ADDENDUM

Reference: Lehi Armory-Cooling Addition and Electrical Service Upgrade
DFCM Project No. 05122470

Subject: **Addendum No. 1**

Project Name: Lehi National Guard Cooling addition

ME-101

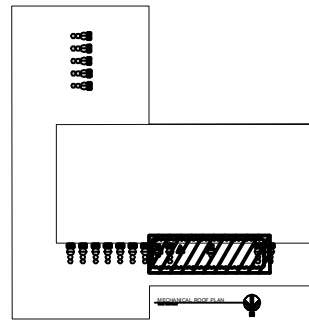
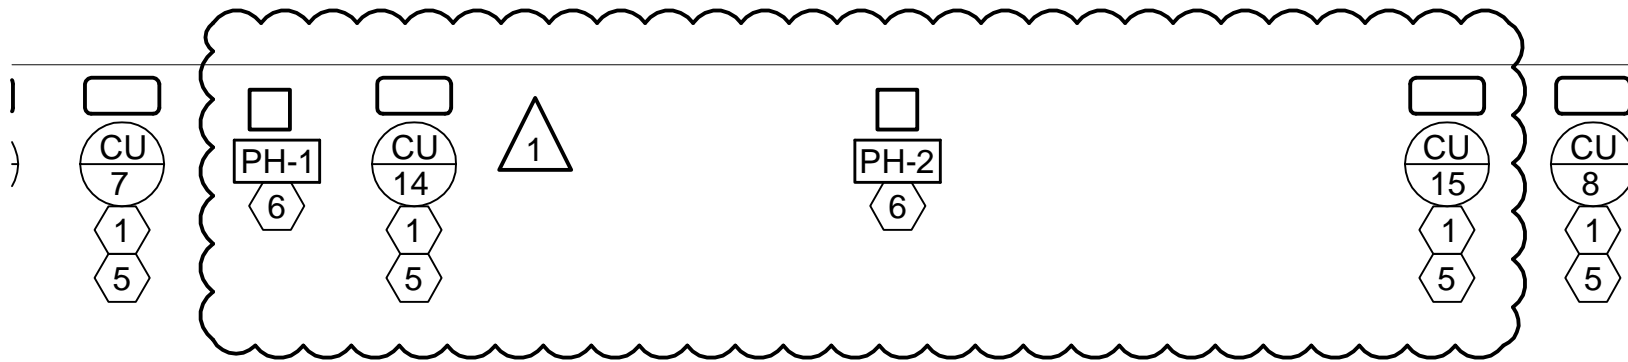
Item VI-1. Sheet ME101: The roof top unit and all associated gas piping and ductwork has been removed.

Item V-3. Sheet ME101, ME102, ME501, ME601: Two new hot water fan coils with cooling coils and condensing units have been added. Penthouses have been added to provide ducted outside air. The new fan coils will connect to existing hydronic piping but will be relocated in the room.
